### AXLE TECH BULLETIN

DATE: 08/02/2021

For Axle Models: D170, D190, D590 (not applicable for FTP versions)

#### Screen Filter Assembly removed (Forward Axle only)

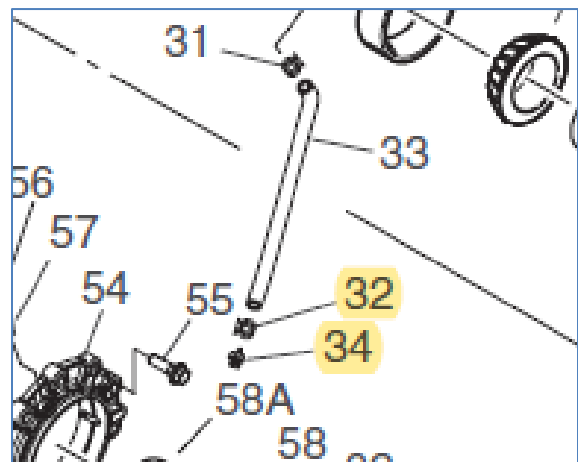
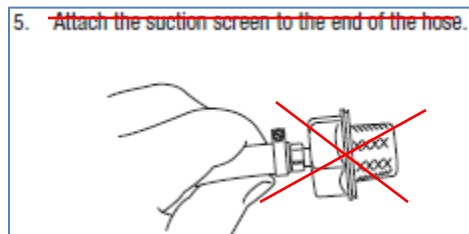
As of the beginning of January 2021, the Screen Filter Assembly is no longer installed to the forward drive head (Hose remains).

On page 7 of the Illustrated Parts List AXIP-0057A, items 32 & 34 are now no longer fitted.

Also, on page 17 of the Service Manual AXSP-0057, install the hose as shown, but do NOT attach the screen and the hose clamp at the end.

**When rebuilding one of these axle units, we recommend also NOT to fit items 32 & 34 anymore.**
